**Re: In the Matter of the Application of Castle Rock Solar LLC for a Site Permit for the up to 150 MW Castle Rock Solar Project in Dakota County, Minnesota
Docket No. IP-7137/GS-24-267
CAH Docket No. 65-2500-40800**

Castle Rock Solar LLC (Castle Rock Solar) hereby submits these reply comments in response to comments filed during the environmental assessment (EA) comment period for the above-captioned dockets regarding its Application for a Site Permit for the up to 150 megawatt (MW) solar energy generating system (Project). These comments primarily focus on: the state permitting process, coordination with local governments and landowners, the applicability of local ordinances and setbacks, emergency response and safety, vegetative screening, and energy costs. In addition, Drea Doffing and Susan Ferrozzo submitted written comments. Further, the Vermilion River Watershed commented on the EA, the Minnesota Pollution Control Agency (MPCA) indicated it had no comments on the EA, and the Minnesota Department of Natural Resources (MDNR) commented on a number of conditions in the draft site permit (or DSP), which was an attachment to the EA.

Figure A: Updated Site Permit Boundary

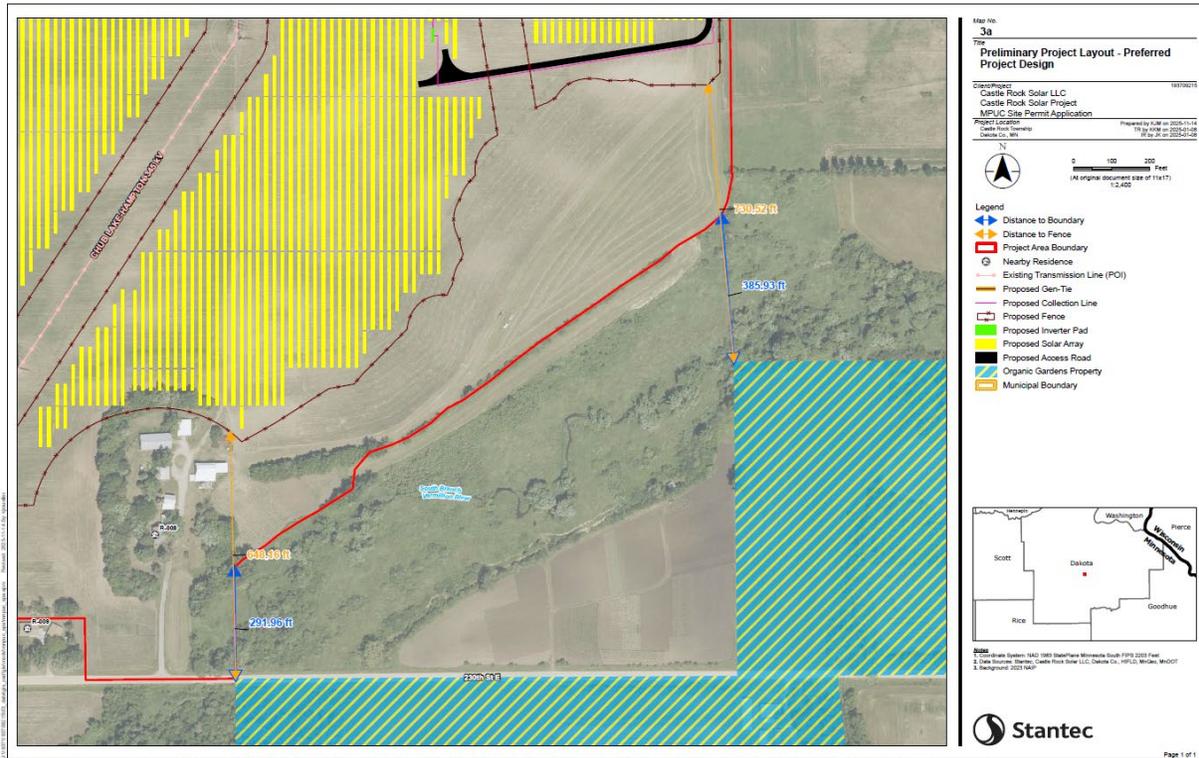
Nonetheless, Castle Rock Solar has reviewed and has determined that—to ensure that no herbicides applied to the Project vegetation would drift onto the neighboring organic farm—a portion of the southeast corner of the Project Area will be removed from the site permit boundary. (**Figure A; Attachment B**.) The area removed from the site permit boundary is within a County shoreland area and mapped floodplain areas so it cannot be used for the solar array. This means that the area removed from the site permit boundary (and any vegetated areas managed with herbicides will be at least 290 feet from the organic farm, which further expands any buffer already employed by the Organic Farm on its property. Castle Rock Solar had previously proposed to plant the area with native vegetation in accordance with the VMP, but will instead allow the underlying

landowner to continue to use the land however it sees fit. In addition, Castle Rock Solar notes that after site preparation, the draft VMP only calls for spot-spraying with appropriate herbicides.²⁸ Castle Rock Solar does not anticipate any use of broadcast herbicide application; thereby further reducing the risk of herbicide drift onto adjacent properties.

Based on these factors—Castle Rock Solar does not anticipate any impacts to the Organic Farm from Project activities. The Draft Site Permit contains a number of conditions related to the Organic Farm that Castle Rock Solar believes, in large part because of its self-imposed setback from the Organic Farm, are no longer necessary or otherwise prudent to impose on the Project. Each is discussed in turn.
